<Our customer's request image with TPS65982>

<Our customer's question and your answer>

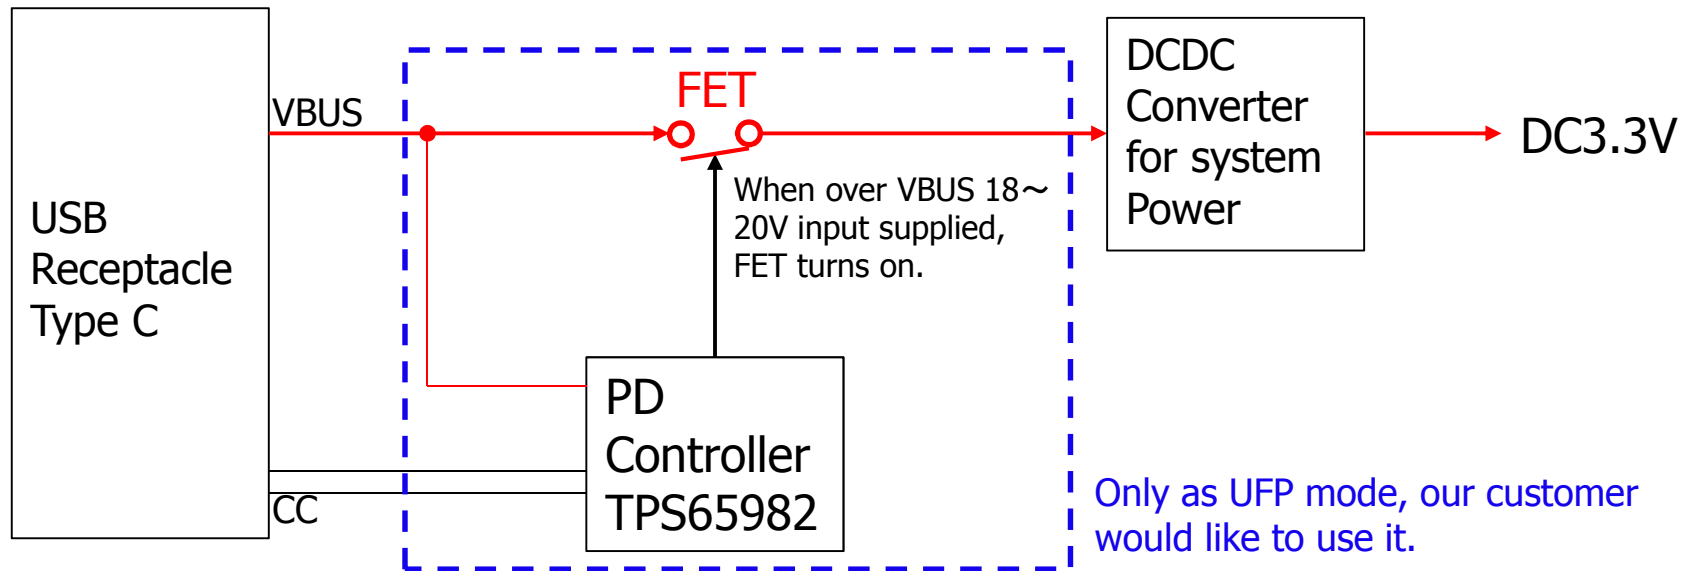
Q1. It is possible to operate the device without CPU.

Q2. After 20V is supplied, the system power is ON with DCDC converter via FETs of HV_GATE1 and HV_GATE2. So, is it possible to adjust the threshold of HV_GATEX operation using Configuration tool?

Q3. If it occurs OCP, the voltage switches off.

Q4. They don't use USB signal. (Only PD device)

A1. OK.

A2. You mentioned "In the [TPS6598X-Config](#) tool, you can set the source and sink PDOs along with FET path to use". So, in this case, is it possible to change the value with "Sink capabilities" or "Source capabilities"? We can't find it on the datasheet.

A3. OK.

A4. OK.
